Noise Occurrence on GDB1363 and GDB1431

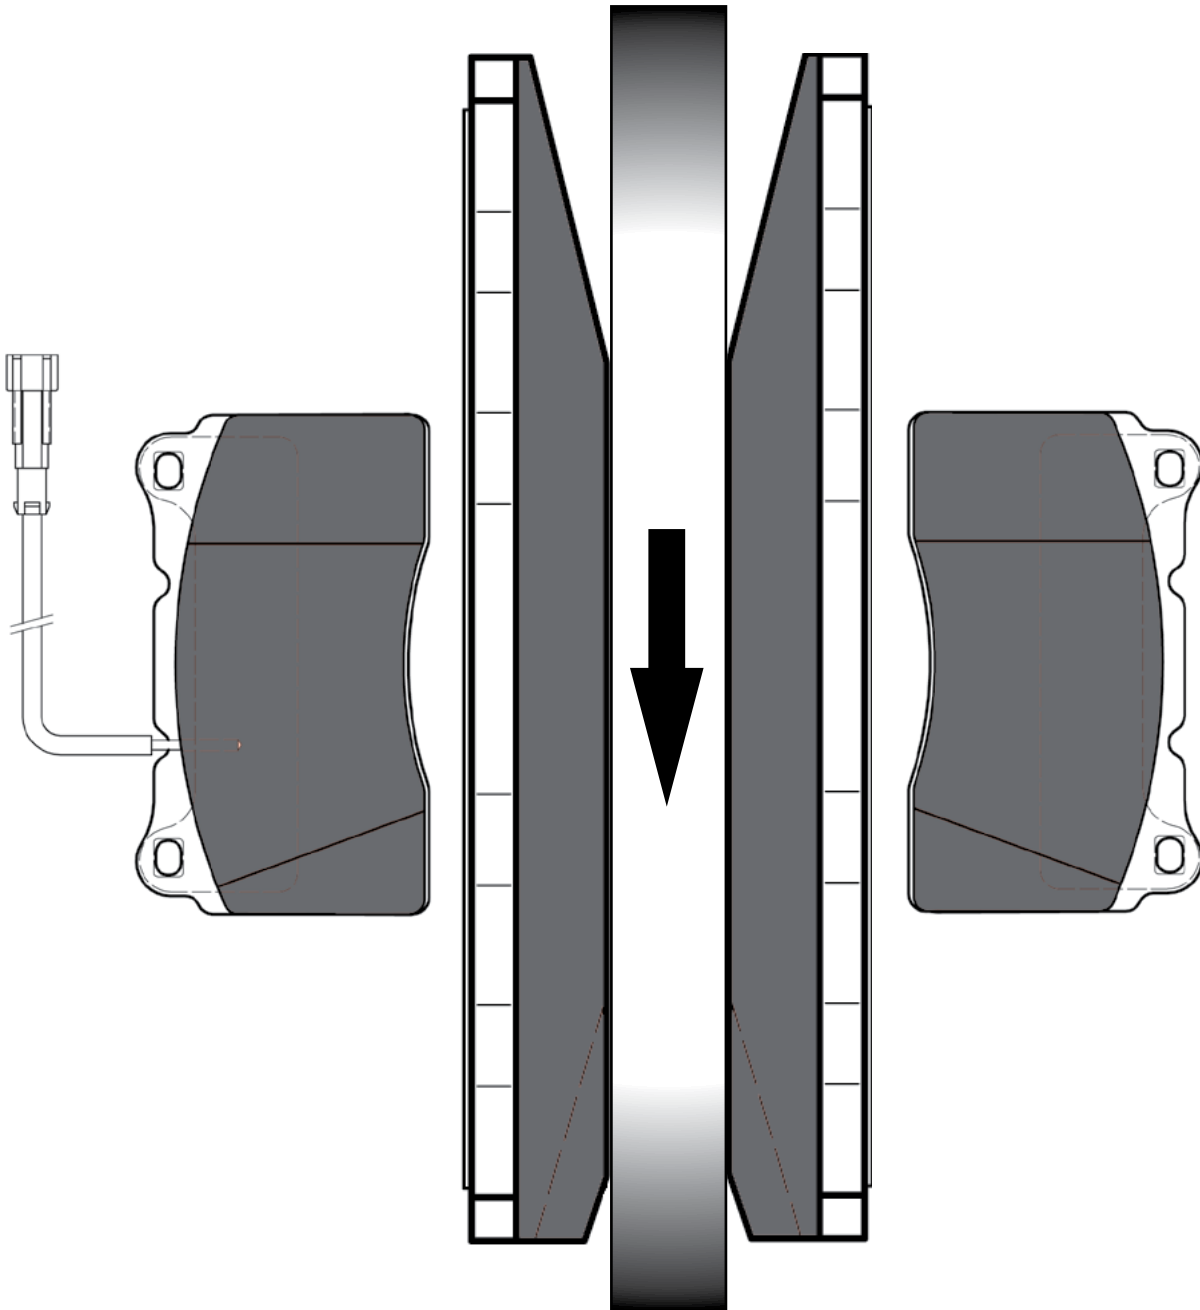
GDB1363 and GDB 1431 are chamfered on one side. The reason for this is to minimise noise. The arrow indicates the disk forward rotation. If the Brake Pads are not fitted as shown above, noise will occur. To ensure the correct fitment in future TRW will print indicator arrows on the back plate.
